# Access Compliance Report

## Public Rights-of-Way

### (Curb Ramps)

Intersection ID: 13763	Main Street: CENTRAL_AV	Cross Street: EASTWAY_DR	Location: NE
ADA ID: A8BF9B1B2988	Ramp Type: Perp	Initial Pass/Fail: Fail	Overall Compliance: No
Severity Score: 8.75			
Codes/Mitigation Info/Possible Solution		Field Measurements/Component Compliance

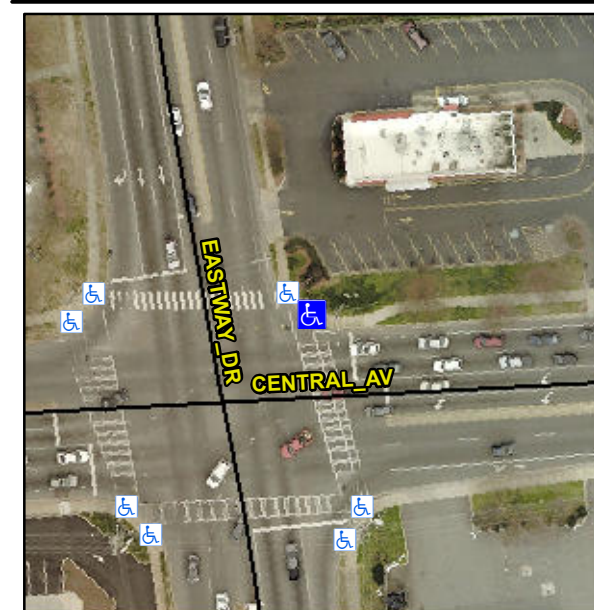
**Not Found, R304.5.1**

Compliance	Description	Data	Compliance	Description	Data
N/A	Ramp Length (in)	71.0	Yes	Ramp Slope (%)	5.2
No	Ramp Width (in)	42.5	Yes	Ramp XSlope (%)	0.9
N/A	Flare Type LT	N/A	N/A	Flare Type RT	N/A
N/A	Flare Slope LT (%)	N/A	N/A	Flare Slope RT (%)	N/A
N/A	Flare Traversable LT?	N/A	N/A	Flare Traversable RT?	N/A
N/A	Landing Length (in)	N/A	N/A	DWS Provided?	N/A
N/A	Landing Width (in)	N/A	N/A	DWS Contrast?	N/A
N/A	Landing Slope (%)	N/A	N/A	DWS Length (in)	N/A
N/A	Landing X Slope (%)	N/A	N/A	DWS Full Width?	N/A
N/A	Landing Curb? (Y/N)	N/A	N/A	DWS Offset (in)	N/A
N/A	Shared Landing?	N/A			
N/A	Gutter Ponding?	N/A	N/A	Gutter Slope (%)	N/A
N/A	Gutter Lip Ht (in)	N/A	N/A	Gutter X Slope (%)	N/A
N/A	Painted X Walk1?	Yes	N/A	Painted X Walk2?	N/A
	X Walk 1 Direction	To S		X Walk 2 Direction	N/A
N/A	X Walk 1 Width (in)	106.0	N/A	X Walk 2 Width (in)	N/A
	X Walk 1 Slope (%)	3.2		X Walk 2 Slope (%)	N/A
	X Walk 1 X Slope (%)	0.7		X Walk 2 X Slope (%)	N/A

**Remove & Replace Entire Ramp.  
Restripe Crosswalk.**
